# 1966 Corvette: Service Bulletin: Air Pump Noise - Air Injection Reactor System

**Bulletin No:** TSB #66-62

**Date:** May 20, 1966

## Date Code

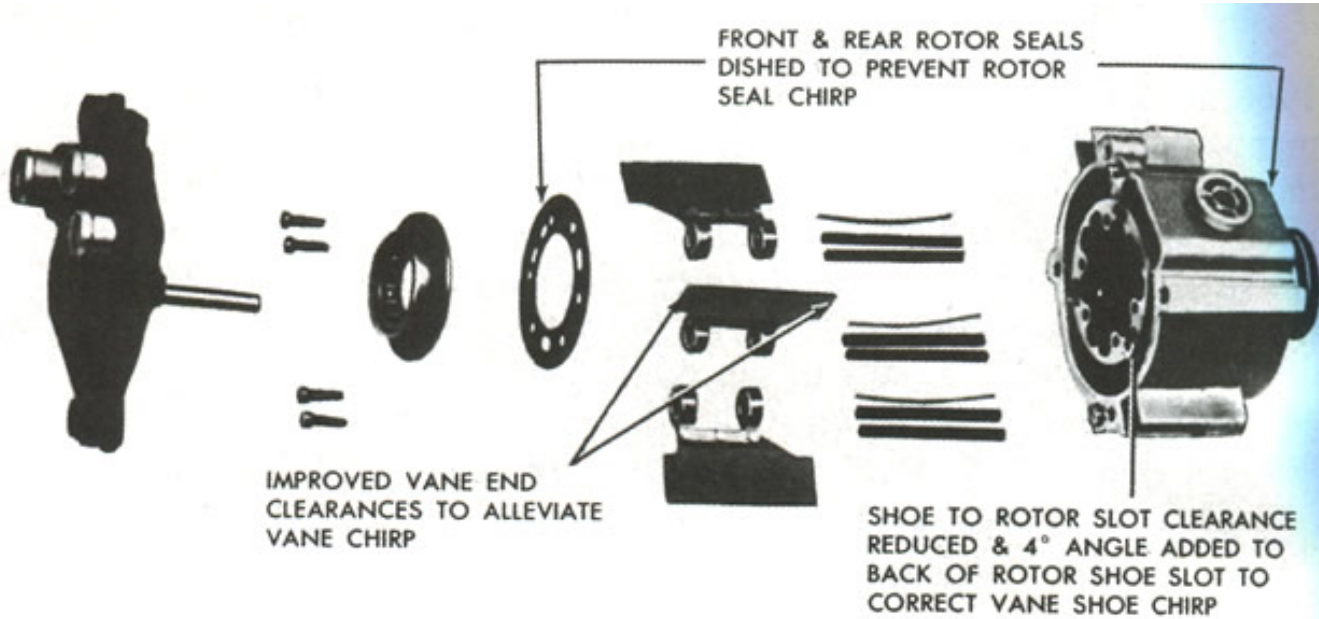
In production, beginning with date code 0126XX stamped on the pump housing, improvements have been incorporated as noted on page 2, to alleviate the above conditions.

If upon completion of the above, the "chirp" still persists, or if the "chirp" is heard at higher pump speeds, the entire pump assembly must be replaced with a pump having a date code of 0126XX or later. Control of pump service components is such that there is no identifying feature to indicate the latest improvements.
